Kroger Fuel Station JSP12-44

Consideration of the request of Landplan Engineering, for Preliminary Site Plan and Stormwater Management Plan approval. The subject property is located in Section 4 at 47045 Pontiac Trail, south of Pontiac Trail and east of Beck Road in the B-3, General Business District. The subject property is 1.08 acres and the applicant is proposing a fuel station consisting of 7 dual customer fuel pumps and a 207 square foot service kiosk.

PLAN REVIEW CENTER REPORT

**SUBJECT: Kroger Fuel Center D-634, JSP12-0044, PSP12-0034,
Traffic Review of Preliminary Site Plan & Traffic Impact Statement**

FIGURE 3
TOTAL FUTURE TRAFFIC VOLUMES

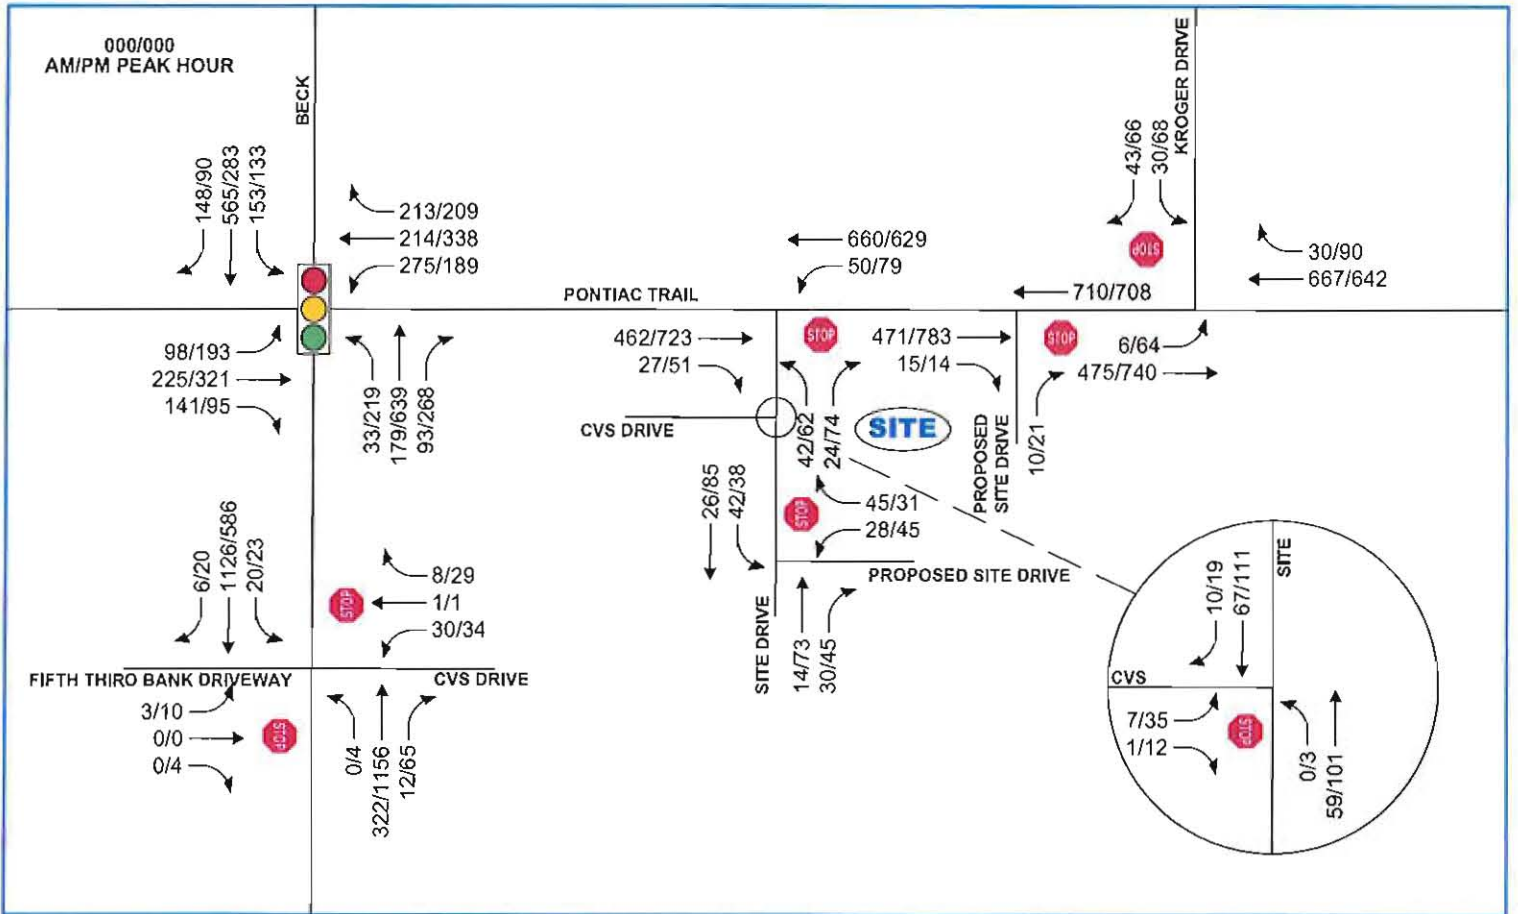
4. The study's trip distribution model and resulting assignments of site-generated traffic appear reasonable. Selected graphics illustrating peak-hour traffic volumes near the site are attached – from both the current study and another (2003) study prepared by another consultant for the abutting shopping center. The recently counted volumes turning into and out of the center compare relatively well to the previously forecasted volumes, an interesting finding given the center's vacancies and the nine years since the earlier study.

KROGER D-514
RETAIL FUEL CENTER
47045 PONTIAC TRAIL @ BECK ROAD
NOVI, MI 48390
DIMENSION CONTROL SITE PLAN

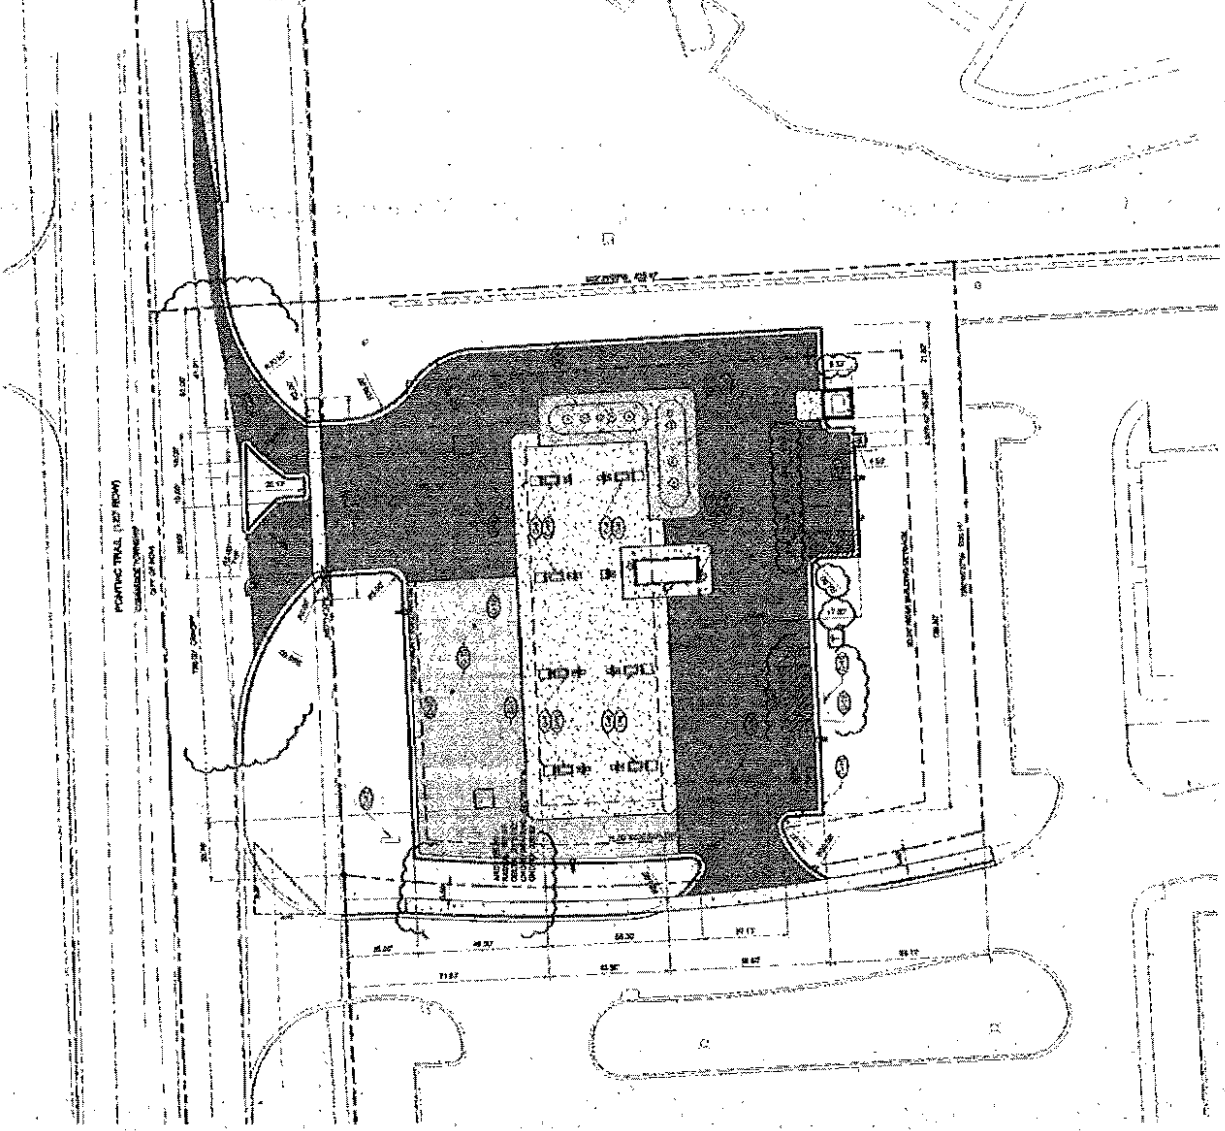
2. Parking Setback: The required side yard parking setback is 10 feet. The applicant has provided an 8 foot setback in the western side yard. **The applicant should adjust the site layout to accommodate the required parking setback or seek a variance from the Zoning Board of Appeals.**

10. As proposed, the exiting radius of the new driveway would encroach at least 13 ft on the frontage of the neighboring parcel; such encroachment is generally prohibited by DCS Sec 216(a)(2). **To avoid a radius encroachment, this driveway should be redesigned as recommended in comment 13 (below).**

14. To maximize the degree to which the new driveway movements are limited to those intended by the design, **the final site plan should include the traffic control signs shown in our attached site plan mark-up.**

1. Acknowledged.
2. The western side yard will be revised to provide a 10' parking set back
3. Parking spaces will be revised to be 19' to face of 6" curb
4. Barrier free sign will be called out and detailed.
5. Dumpster screening details will be included.
6. Landplan will coordinate signage Jeannie Niland.
